WINTEN
PROPERTY
GROUP

Response to Submissions

North Sydney Commerce Centre Concept Plan

Submitted to
Department of Planning
On Behalf of Winten Property Group

Figure 1 – A fully complying irregular building envelope

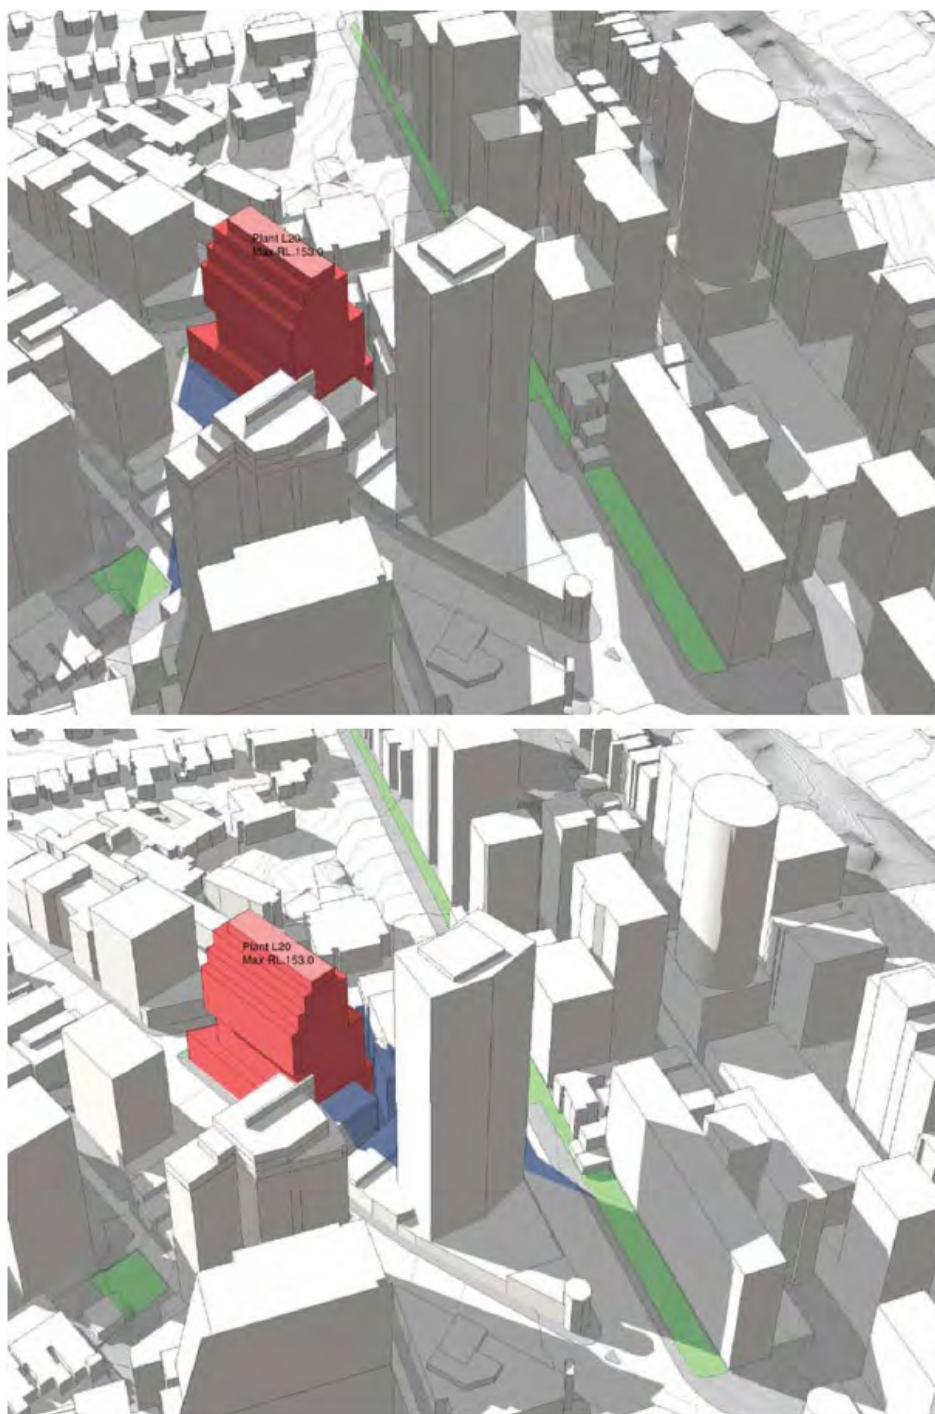
The proposed building envelope results in additional overshadowing of nearby Special Areas (as identified in the North Sydney LEP 2001). Further envelope massing options should be prepared which demonstrate maintenance of solar access to the Miller Street and Don Bank Museum Special Areas between 10am and 2pm throughout the year, with particular reference to the Equinoxes. The options should indicate the impact on floor space and floor plate areas.

An envelope study (see **Attachment C**) has been undertaken to demonstrate the various building envelopes that maintain solar access to the Miller Street Special Area and the Don Bank Museum Special Area between 10:00am and 2:00pm throughout the year, and on the Equinoxes. When combined to consider both Special Areas, a fully complying scheme would result in:

- a highly irregular envelope (see **Figure 1**), which would produce a maximum height of RL153m, and a maximum GFA of 25,485m² (a loss of 19,285m²); or
- a more regular building envelope (see **Figure 2**), which would produce a maximum height of RL146.4m, and a maximum GFA of 23,235m² (a loss of 21,535m²).

Figure 9 - An example of a possible articulation to the eastern façade

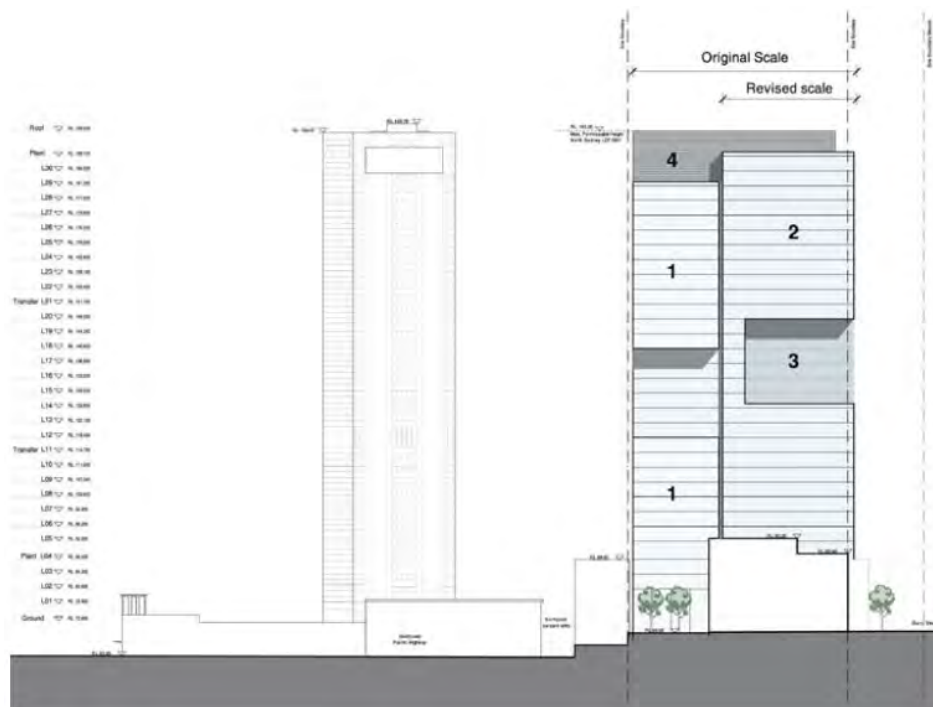
The Department is of the view that the envelope of the upper levels of the proposed building will be visually prominent when viewed from the east and west at the edges of the North Sydney Centre.

As a result any design changes which require a reduction in the mass of the upper levels of the building would realistically require reducing the height of the tower. Whilst no changes are proposed to the Concept Plan envelope, the articulation of the building will be undertaken as part of the detailed design and provide opportunities to address the perceived visual prominence of the upper levels.

Attachment C and **Figures 8** and **9** illustrate how this could potentially be achieved through a series of studies.

Figure 10 – Impact of the non compliance with Draft LEP 2009 RL190 height control on the Miller Street Special Area

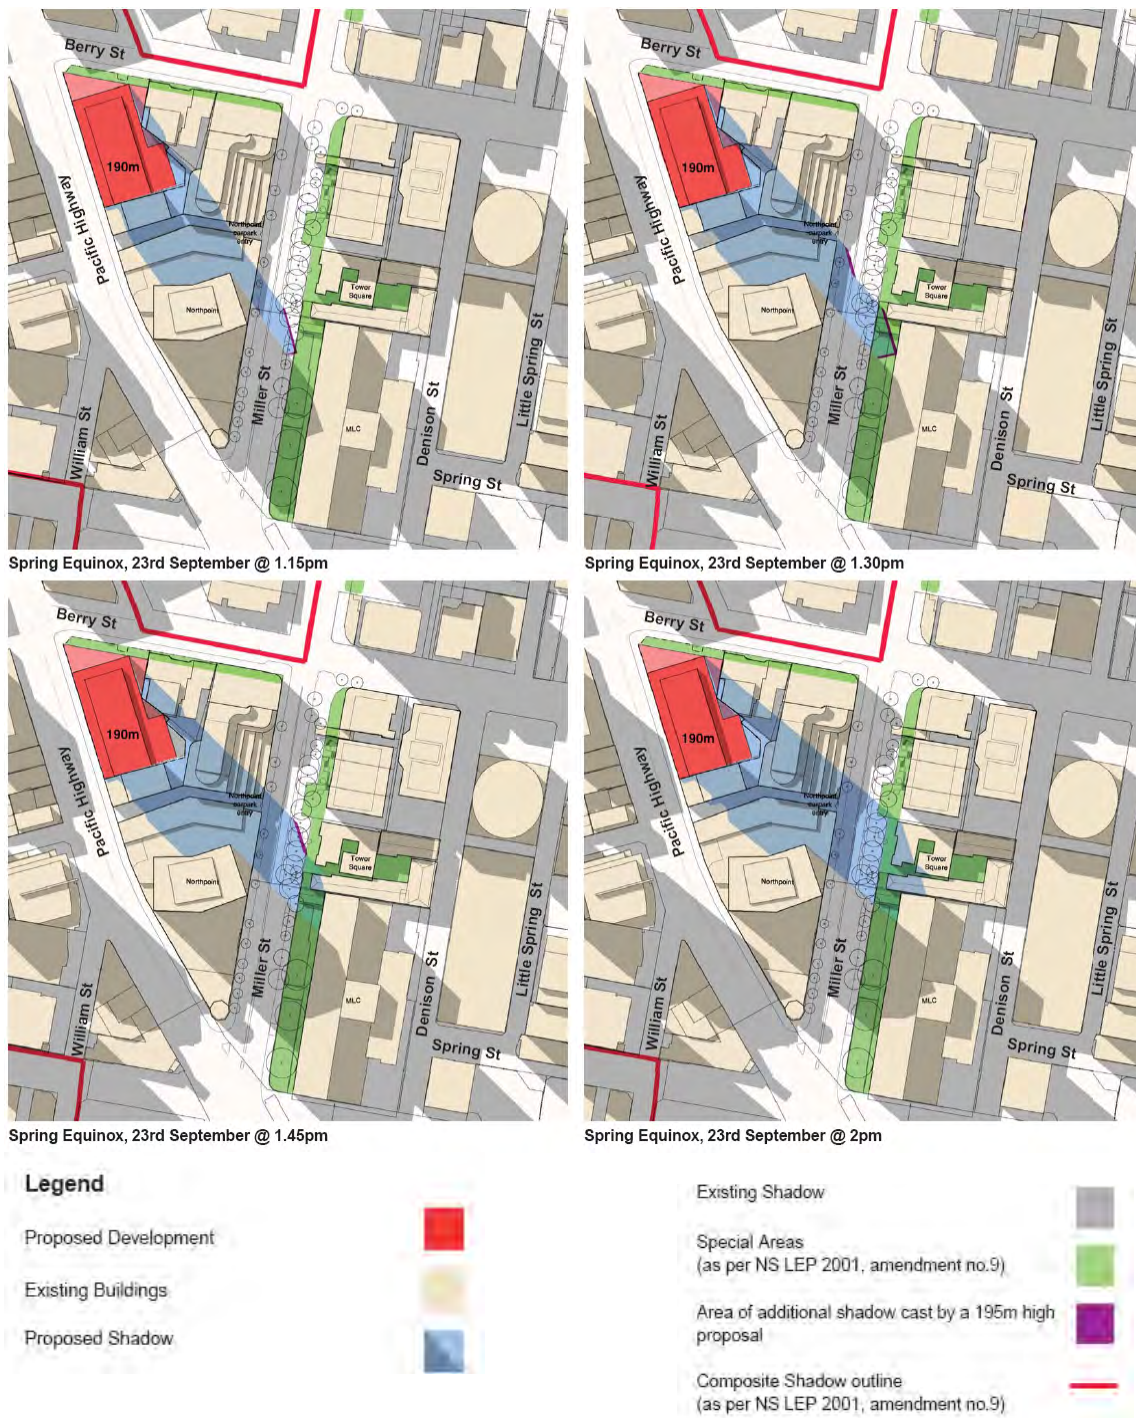
In its recommendations to the Department, Council recommended emphasising the 'relevant' height controls of the yet to be exhibited Draft LEP 2009 for the site of RL 85 and RL 190 to reinforce overshadowing controls.

In regards to Council's recommendation that the Draft LEP 2009 heights be adopted to reinforce the overshadowing controls, Section 5.2 of the EAR demonstrated as a result of the overshadowing provisions that apply under LEP 2001 and Draft LEP 2009, the maximum numeric building heights set out in Draft LEP 2009 are irrelevant as the maximum height achievable on the site under a complying scheme is RL 136.9 and a 5 metre reduction to the tower to RL 190 will still result in overshadowing occurring on the Don Bank Museum and Miller Street Special Areas.

The overshadowing impact of a concessional reduction to the maximum building height to RL190, as recommended by Council, is shown **Figures 10-12** below. The analysis demonstrates that even on the days with the greatest affectation, the 5m reduction to the tower will have negligible impacts on the degree of overshadowing on the Miller Street and Don Bank Museum Special Areas during the Equinoxes or on the Shore School during the Winter Solstice. Notably the reduction would make no significant difference on the area of additional overshadowing on the Miller Street Special Area at 2pm on the Spring Equinox.

Figure 15 – Ground Level perspectives from the pavement on the east side of the Pacific Highway
Source: Bates Smart

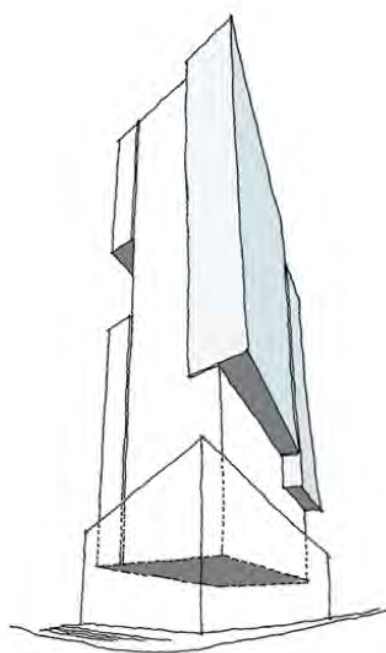
The proposed building envelope is inconsistent with Council's setback controls on the Pacific Highway alignment of the site.

The Design Review Panel also noted that the non-compliance with the setback and recommend that a ground level perspective from the pavement on the east side of the Pacific Highway looking south be prepared to demonstrate that the protrusion is appropriate and in context with development on the eastern side of the Pacific Highway.

Bates Smart has prepared multiple perspectives (see **Figures 14-15**) which illustrate the proposed scheme. The perspectives clearly demonstrate that the building will sit in front of the existing North Point tower, which has a 0m setback, and the protrusion will not be overbearing on the streetscape and is appropriate in context with the development on the eastern side of the Highway.

Figure 16 – Potential soffit design options

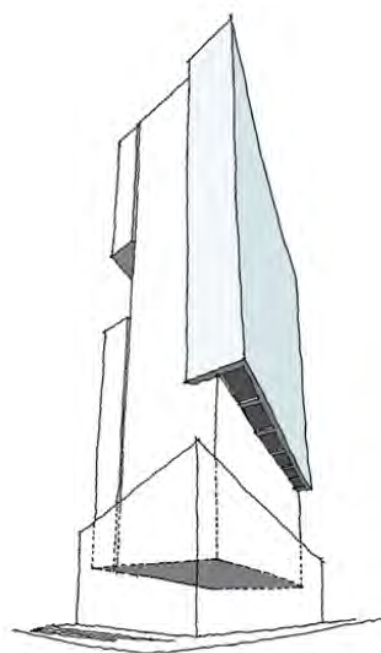
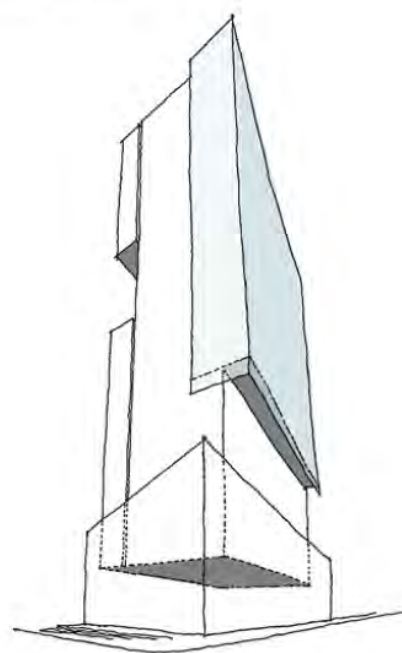
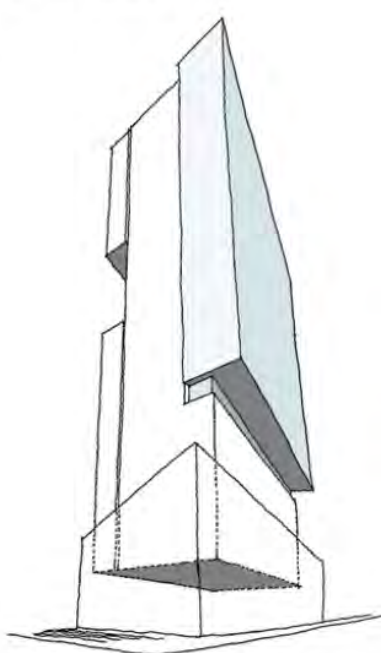
Further options for the design and appearance of the expressed cantilevered envelope at Level 10 on the Pacific Highway elevation should be provided and should include options for the design and appearance of Level 10 soffit as seen from the public domain.

The design of the Level 10 soffit as seen from the public domain will correspond with the final fabric of the building. As a result the design and appearance of the soffit will be developed as part of the detailed design of the building. Possible design solutions (as shown in **Figure 16**) could include:

- articulated form;
- expressed structure;
- floating skirt; and
- recessed floor for articulation of form.
